Notice of Allowability

09/869,493

HOOVER, ALAN ANDERSON

FIG. 5

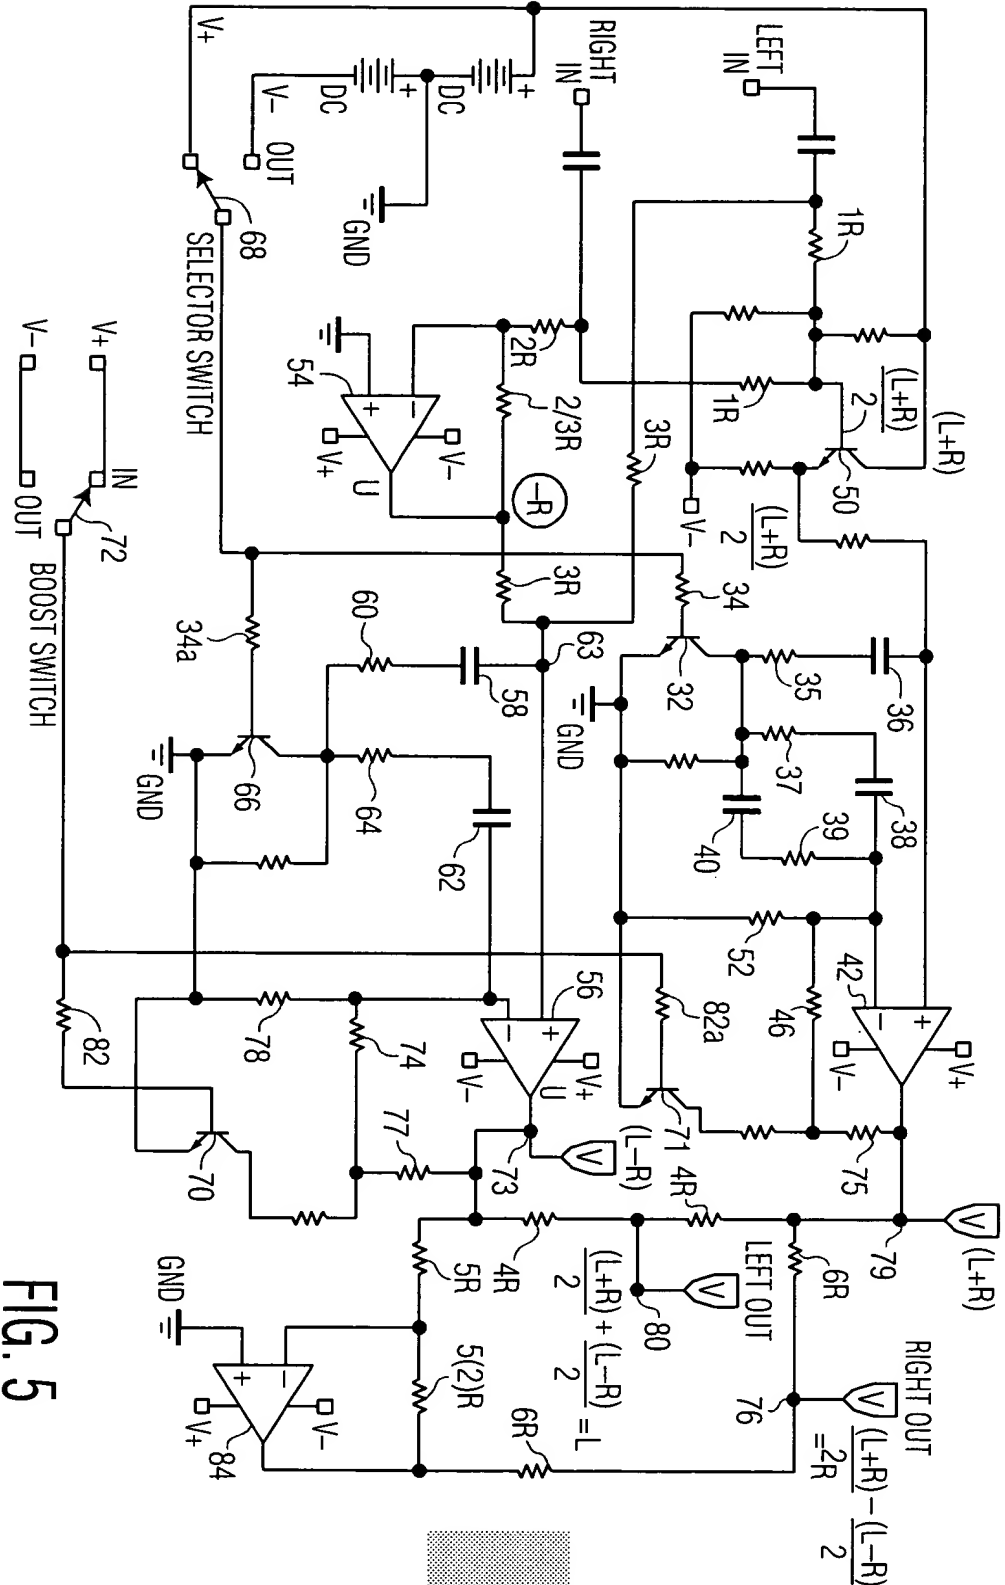
The attached sheet of drawing includes changes to Fig. 5. In Fig. 5, the reference numeral for the resistor connected to the base of the transistor 71 has been changed to 82a, the reference numeral for the resistor connecting the output of the opamp 42 to a terminal of the resistor 46 has been changed to 75, the reference numeral for the resistor connecting the output of the opamp 56 to a terminal of the resistor 74 has been changed to 77, the reference numeral for the node at the output of the opamp 42 has been changed to 79, and the reference numeral of the opamp 74 has been changed to 84.

Fig. 5 has been replaced by attached Fig. 5.
